Amendments/Additional Information

From: [Tim Harrison \(BHD Partnership\)](#)
To: [Ailsa Teasdale](#)
Cc: [Planning](#);
Subject: Application ref. NYM/2017/ 0633 / FL -- Proposed Slurry Lagoon at High Farm, Ugglebarnby, Sleights, for Mr.r. and Mrs.A.Harland
Date: 08 December 2017 14:34:21
Attachments: [D11221-03C.pdf](#)
[D11221-04C.pdf](#)
[D11221-05C.pdf](#)
[D11221-06C.pdf](#)

DRAWING No: D11221-03 REV: C

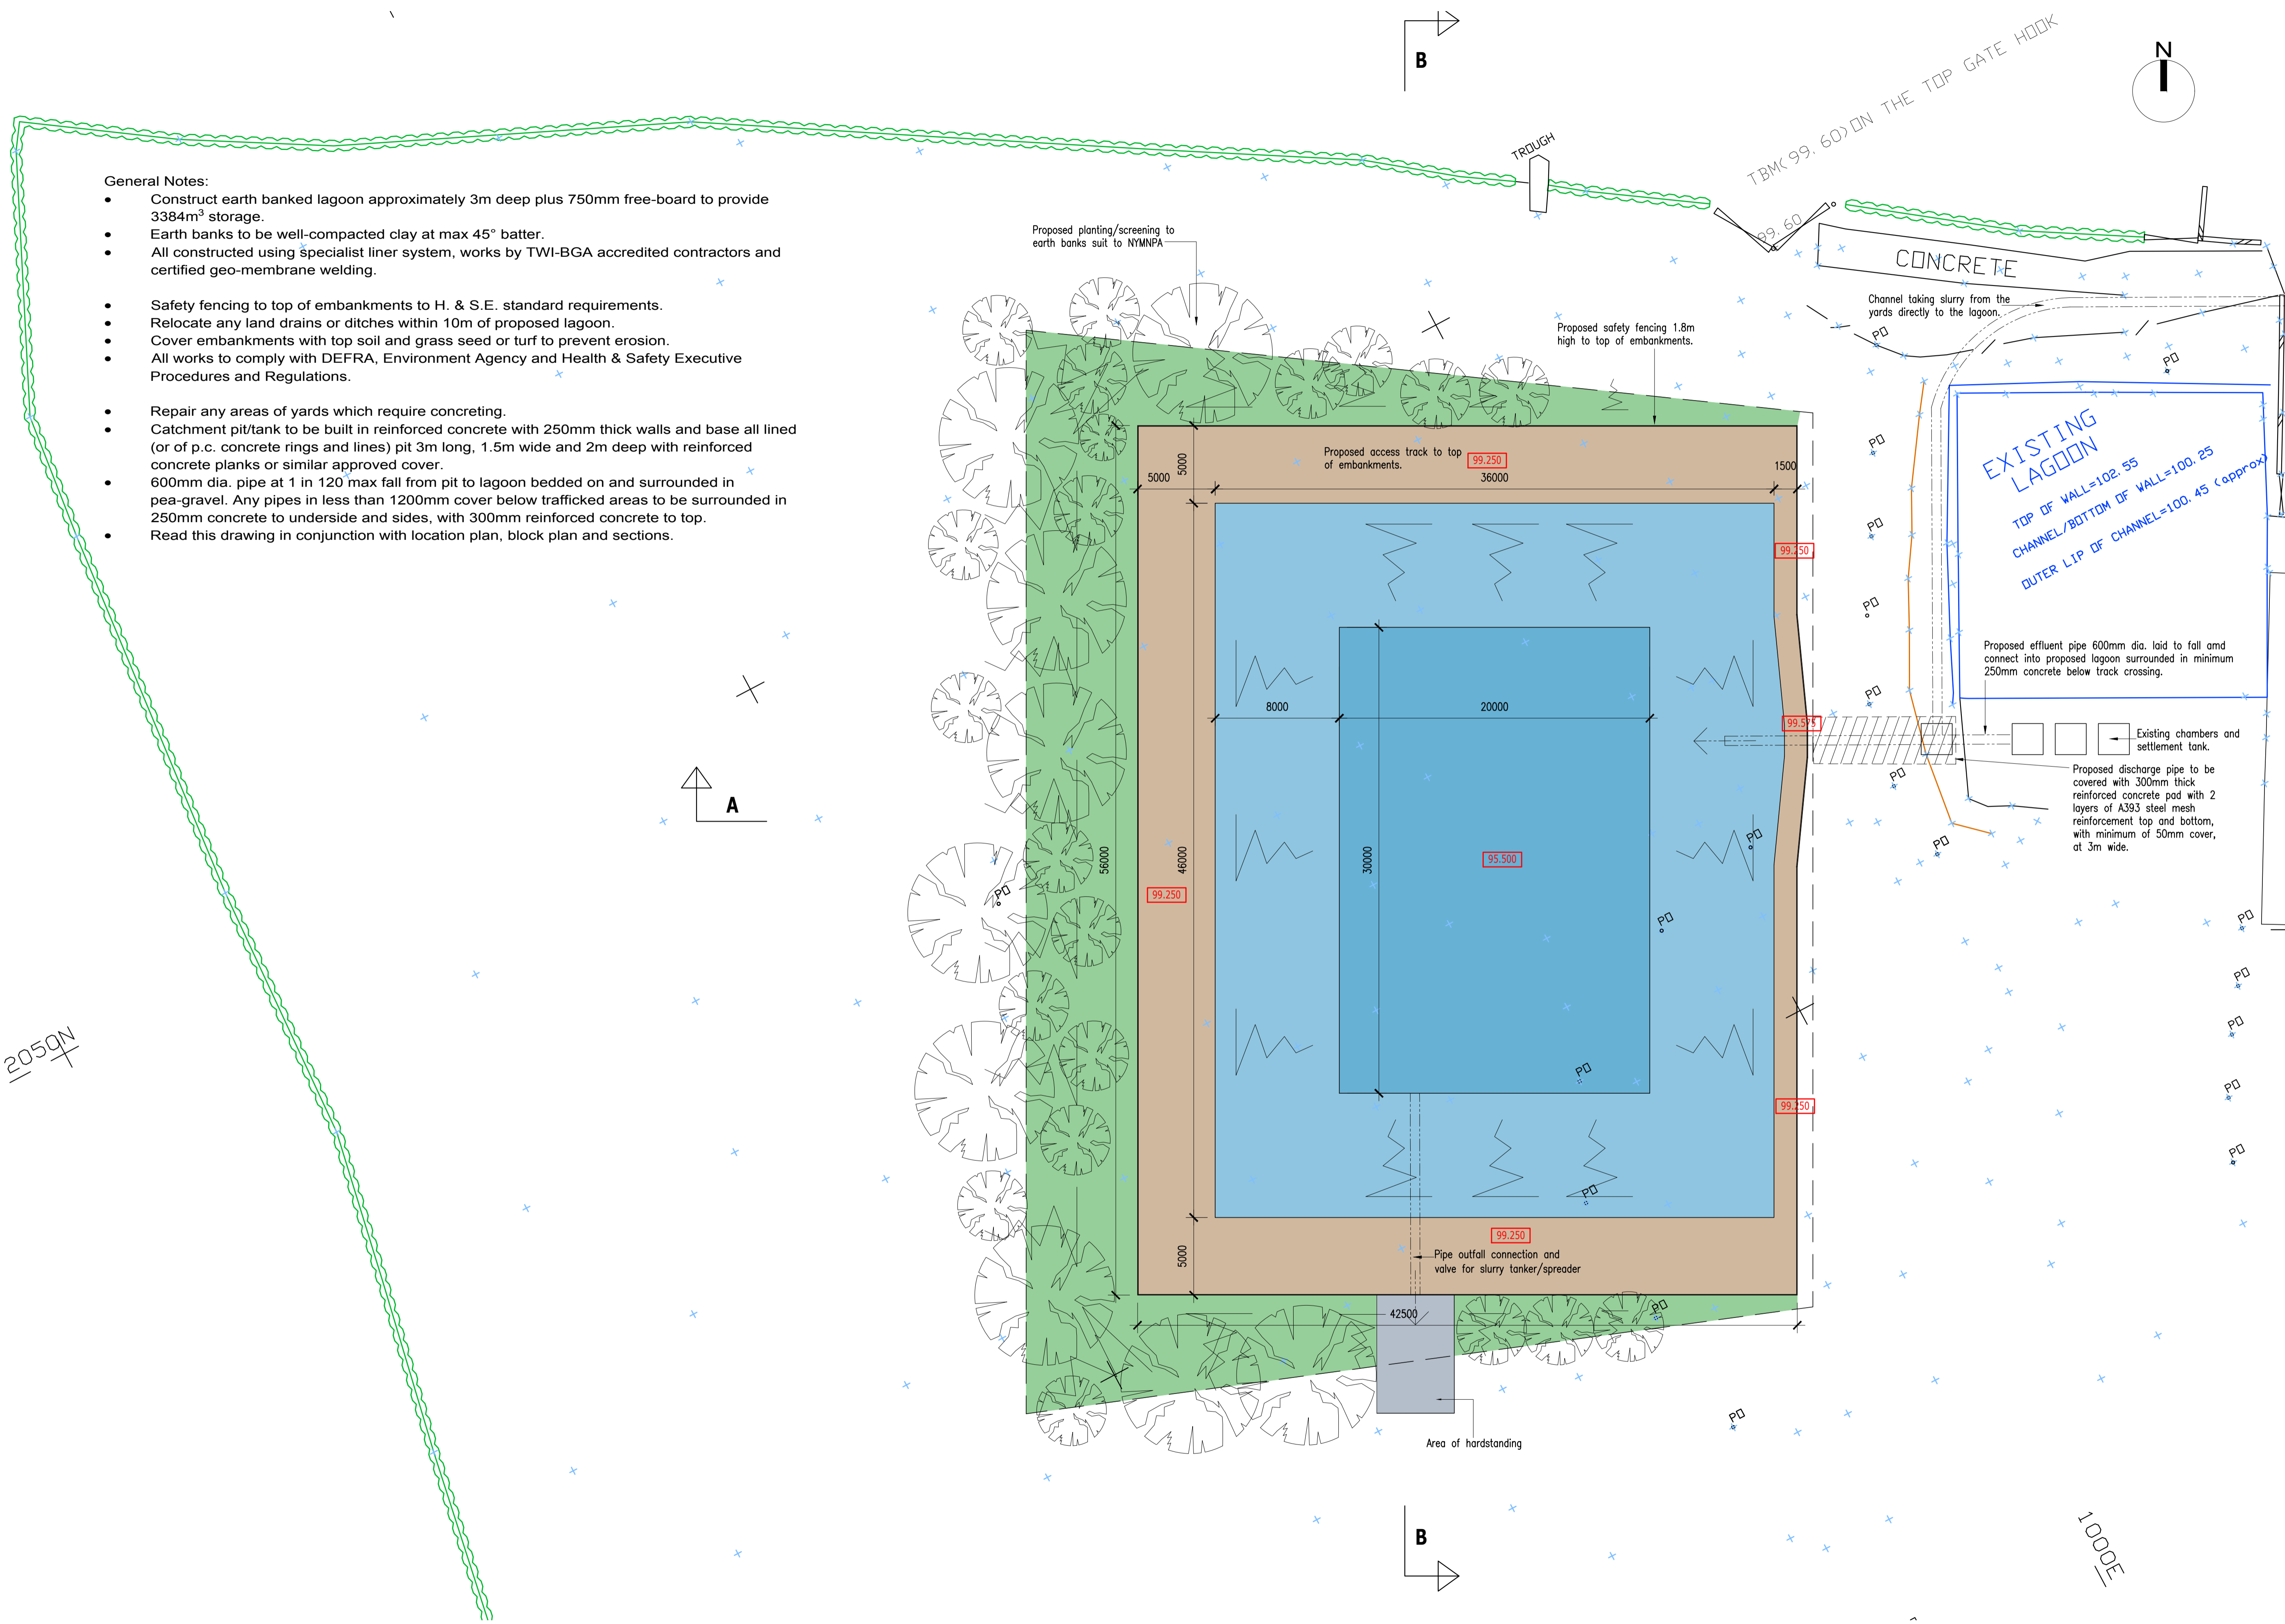
With regard to the above application and the size of the lagoon it has been brought to our attention that the proposed drawings as submitted made a reference to 1025m³ storage in the annotation .

However this figure was calculated as an average of the area of the proposed lagoon and as a result does not reflect the cubic capacity of the proposed lagoon.

Therefore we have adjusted this figure on the proposed drawing nos D1121-03C , 04C, 05C, and 06C to 3384m³ which is the correct slurry capacity.

- General Notes:**
- Construct earth banked lagoon approximately 3m deep plus 750mm free-board to provide 3384m³ storage.
 - Earth banks to be well-compacted clay at max 45° batter.
